Docket No. 50-219

SUBJECT: SUMMARY OF MEETING ON SEPTEMBER 9, 1980 TO DISCUSS
JERSEY CENTRAL POWER AND LIGHT COMPANY'S RESPONSE
TO OUR JULY 10, 1980 LETTER ON SEP TOPIC III-5.B, 1,
PIPE BREAK OUTSIDE OF CONTAINMENT FOR THE OYSTER
CREEK NUCLEAR GENERATING STATION

SCHEMATIC DIAGRAM
EMERGENCY CONDENSER SYSTEM

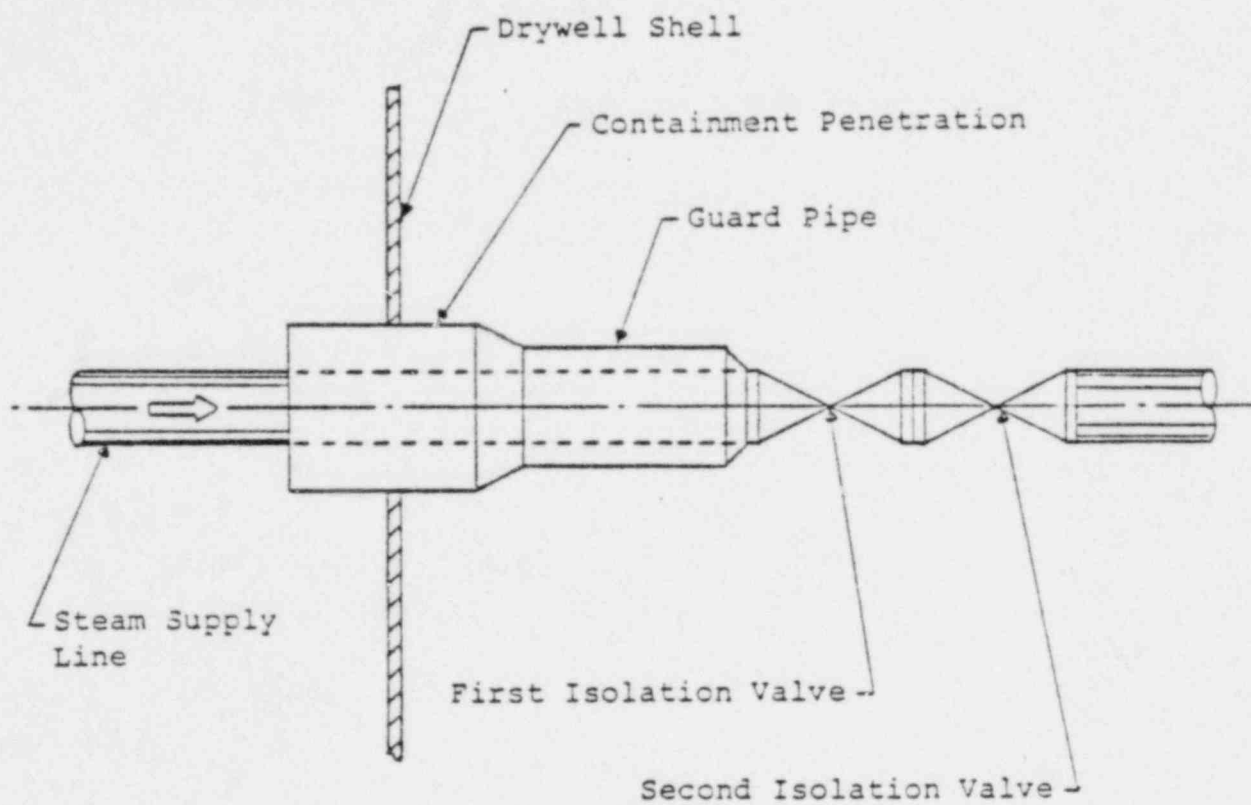
One concern is that the effects of a postulated break could prevent the two isolation valves on the steam supply line from closing. The licensee stated that there is not sufficient room inside containment to install another isolation valve. Barriers would be massive because of the size of the lines. Accordingly, they are going to propose a leak detection system based on the concept that the pipes will leak before they break. JCP&L is considering two concepts: (1) an acoustic system designed by Westinghouse, and (2) a moisture detection system. We indicated that they should also consider including augmented inservice inspection.
